**DOCKET NUMBER 50-483
CALLAWAY PLANT
UNION ELECTRIC COMPANY
RESPONSE TO REQUEST FOR ADDITIONAL INFORMATION
ON REVISION TO TECHNICAL SPECIFICATION 5.5.9
"STEAM GENERATOR (SG) TUBE SURVEILLANCE PROGRAM"**

**REQUEST FOR ADDITIONAL INFORMATION
REVIEW OF THE CALLAWAY PLANT APPLICATION
FOR REVISION TO TECHNICAL SPECIFICATION 3/4.4
TAC NUMBER: MB1214**

Figure R20-1, Sample: 120196-03
ID pit: 1

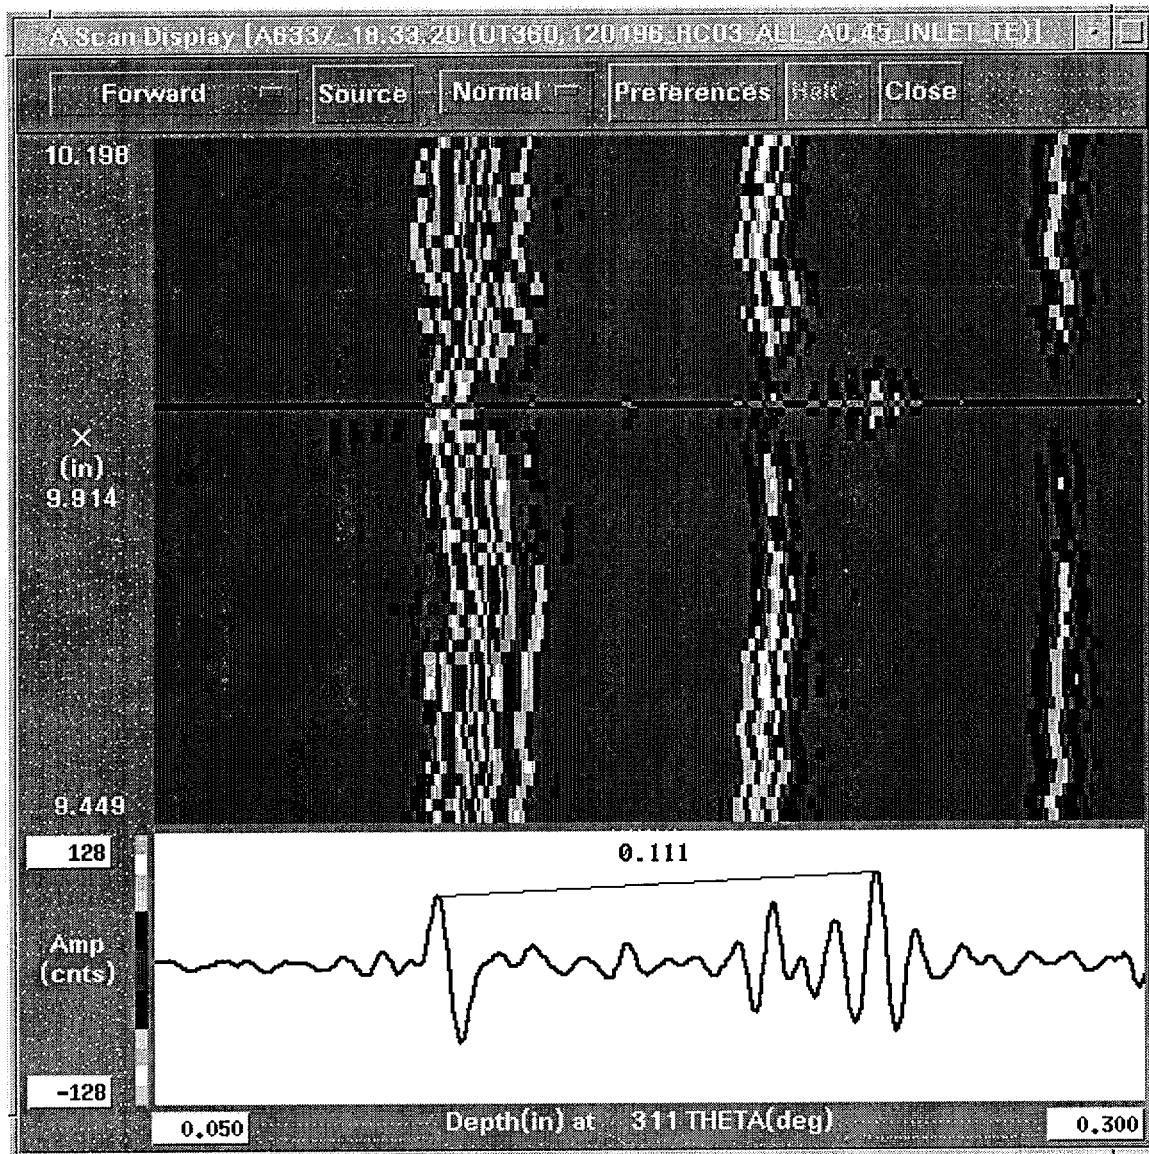
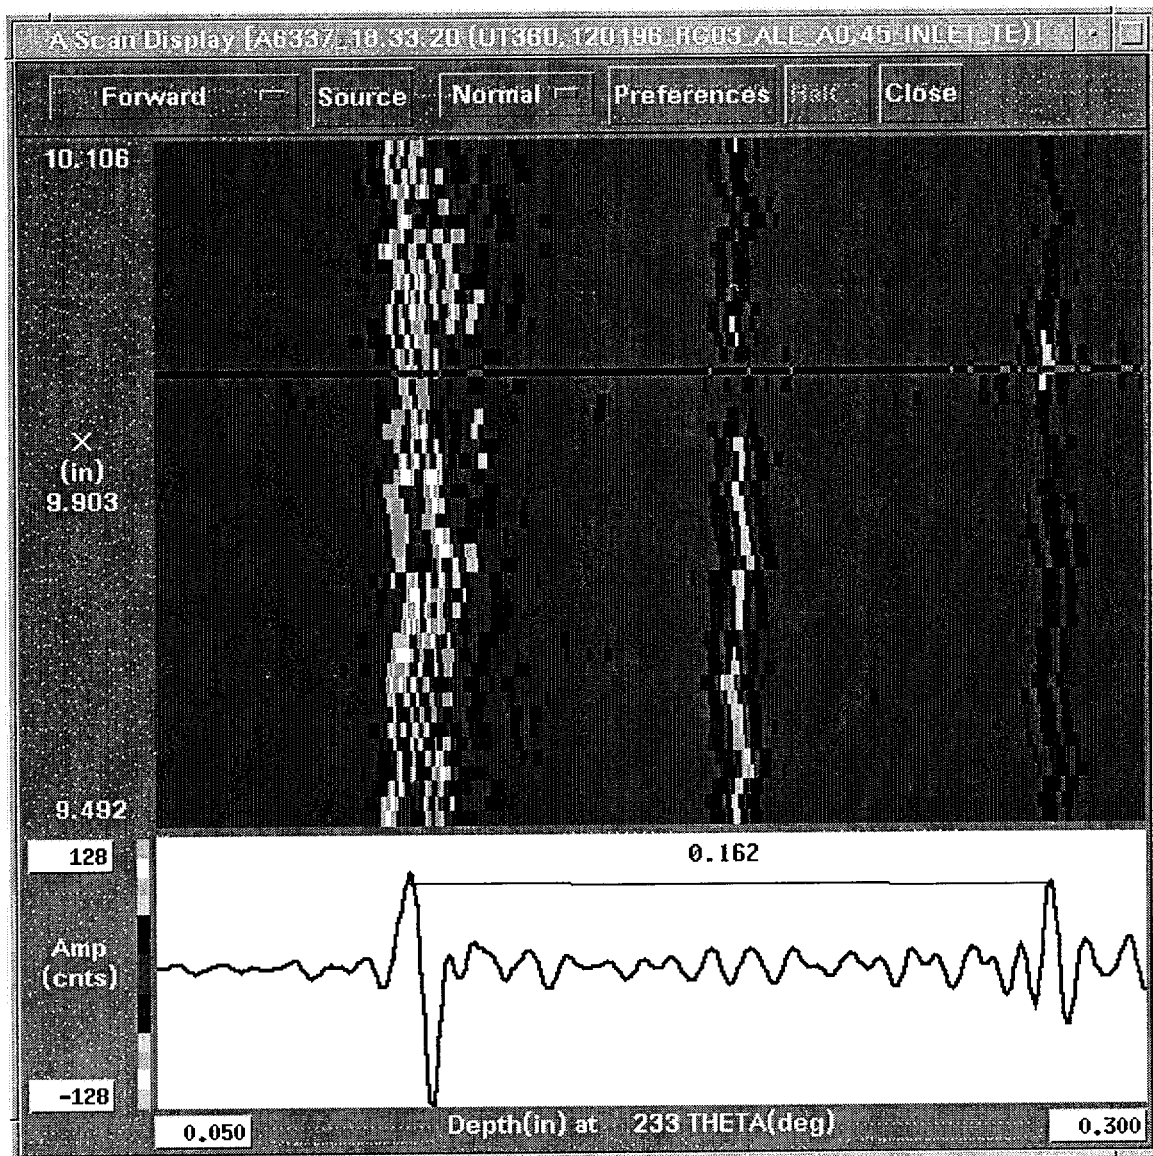
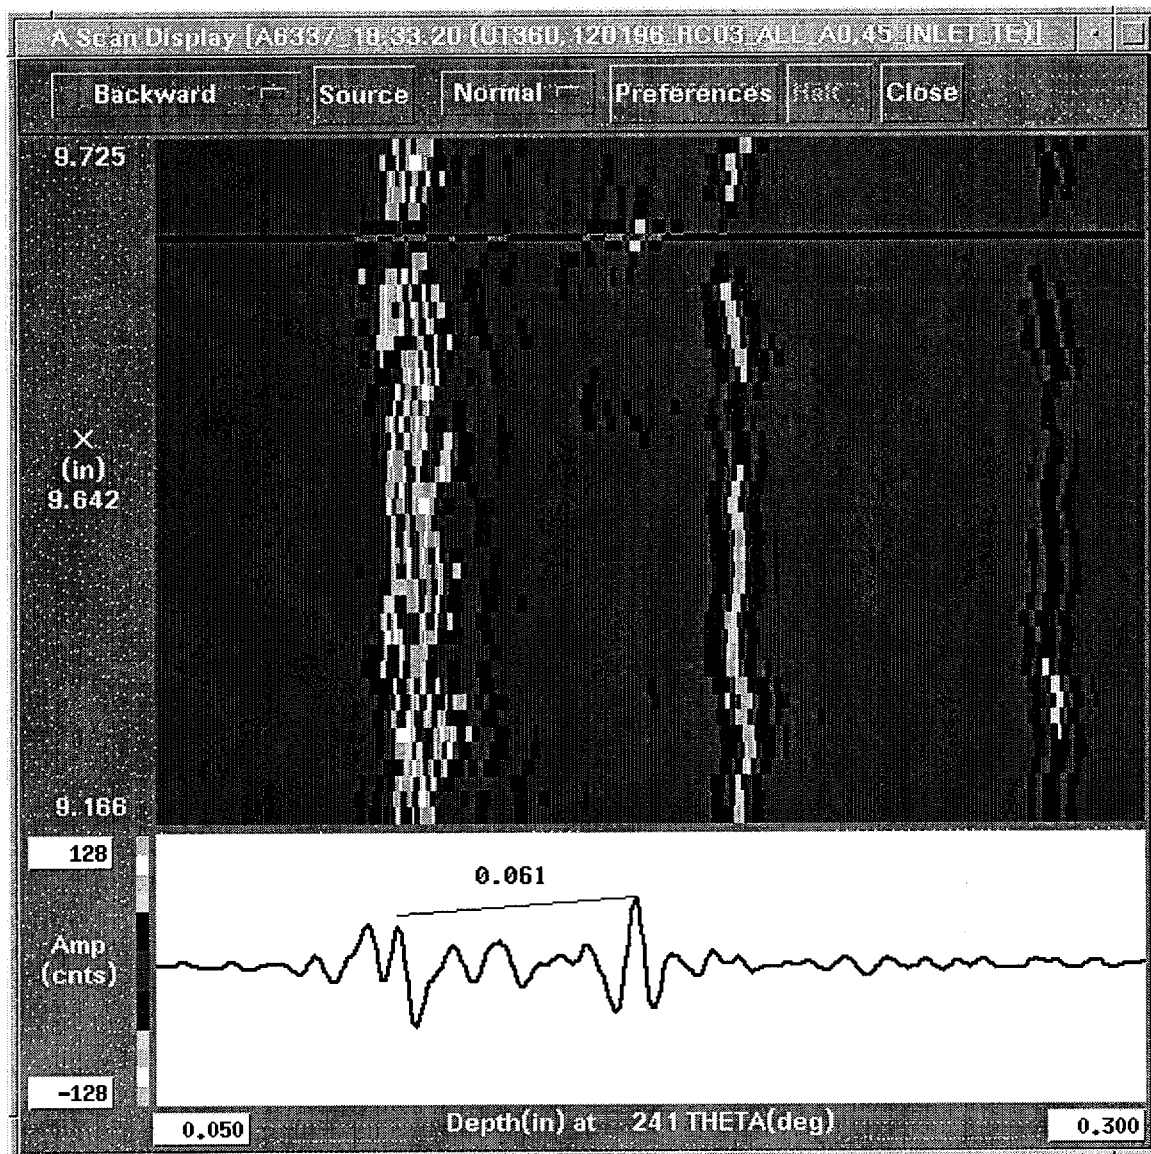
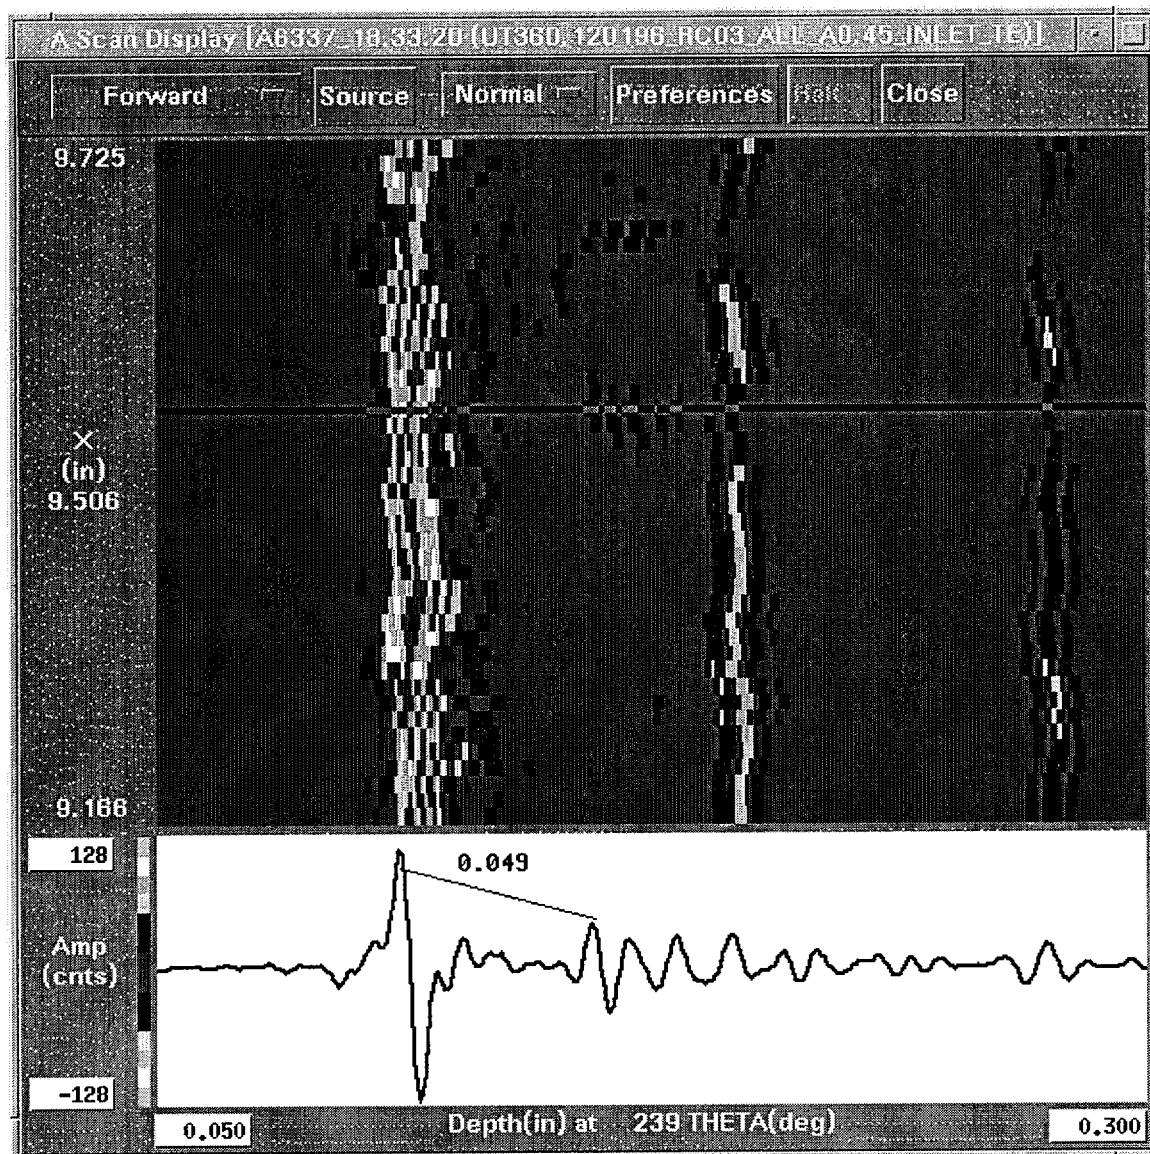
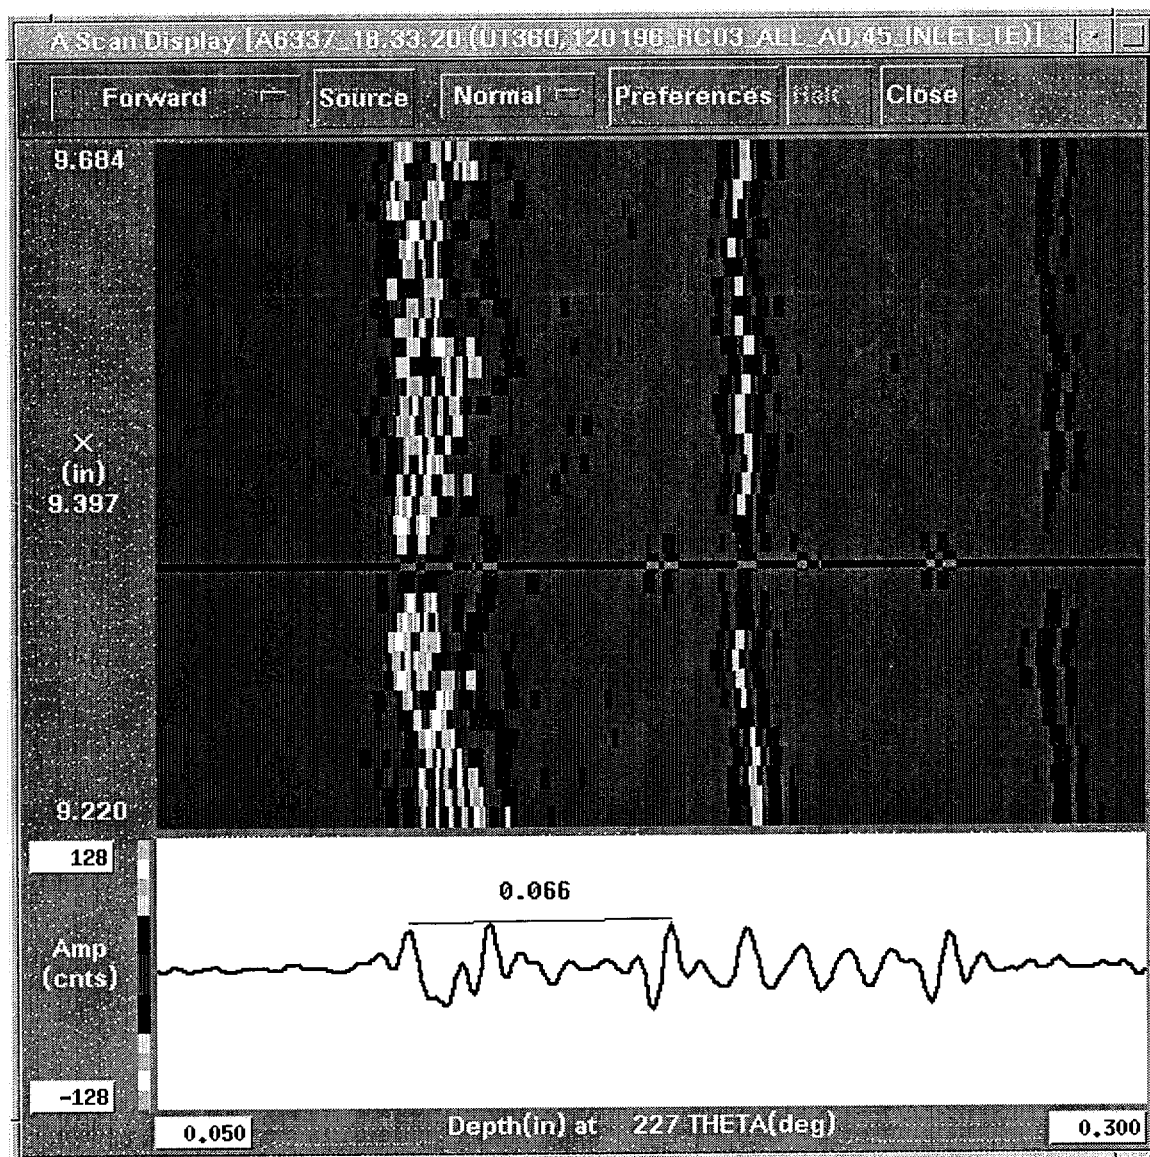
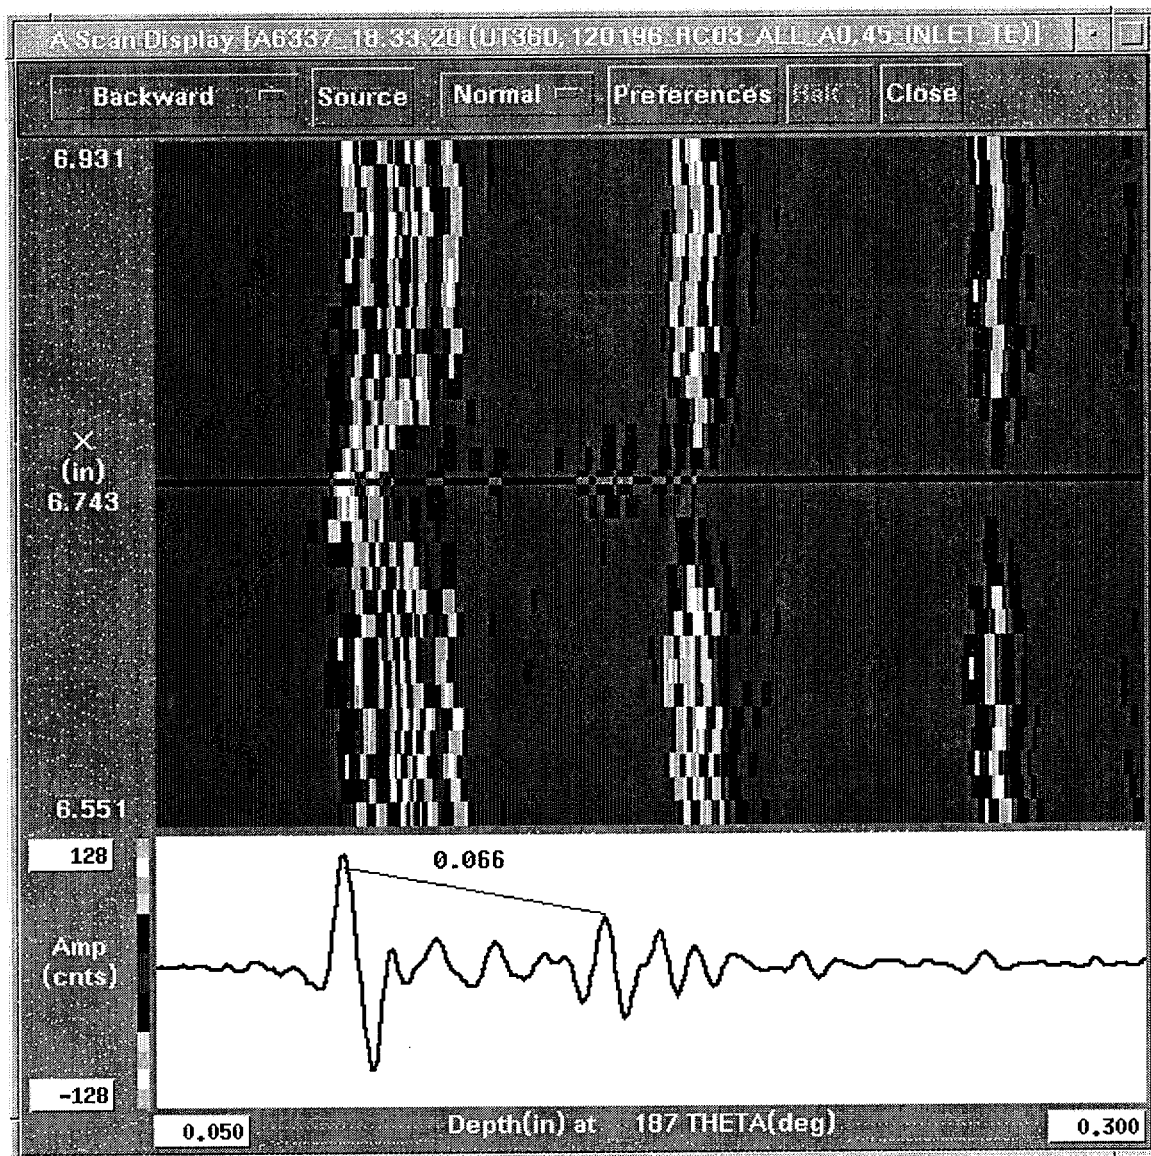
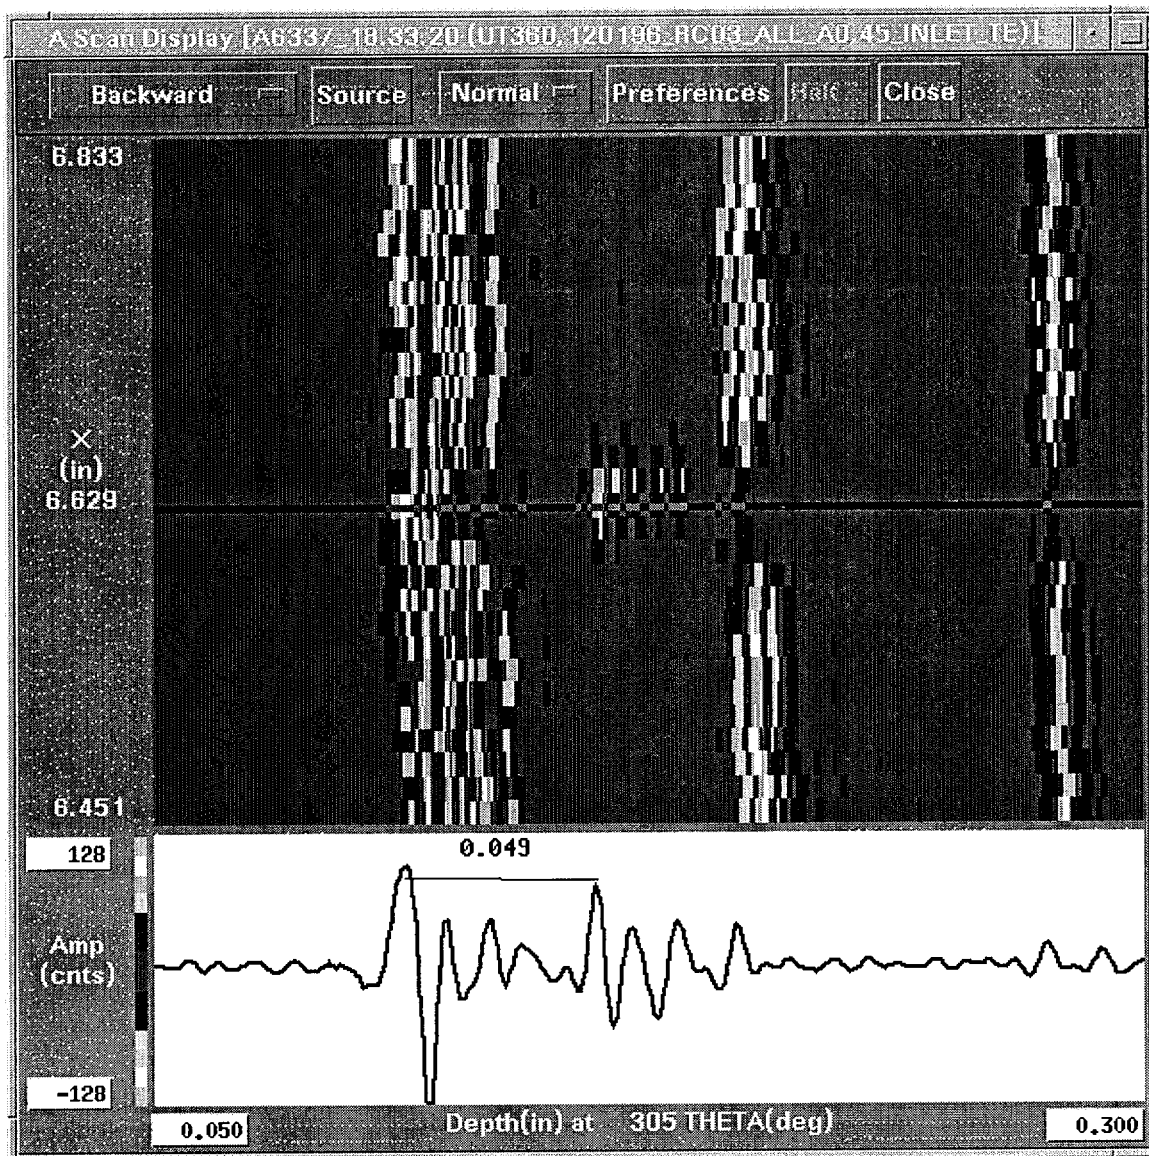
RAI # 20. The report states that because ID pits are conservatively assumed to be 100% through the sleeve, no depth sizing is required. However, the report states that UT can detect the ID pits. The report states that "ID pits with a depth greater than one wavelength" which is approximately 0.006 inches for a 10MHz transducer and a 0.058 inch/ μ s speed of sound in water can be detected because there should be at least two distinct surface reflections. Please provide UT data to support your ability to detect ID pits. (Page 11-45, BAW-10219P, Rev. 4)

The quality control inspector performing the replicant measurements indicated that the values for depth were accurate to +/- 0.002 inch.

UT estimated depth: $(0.111 * 0.058 / 0.233) = 0.028$

Actual pit diameter: 0.020
Pit depth (pin gauge): 0.017

UT estimated depth: $(0.162 * 0.058 / 0.233) = 0.040$
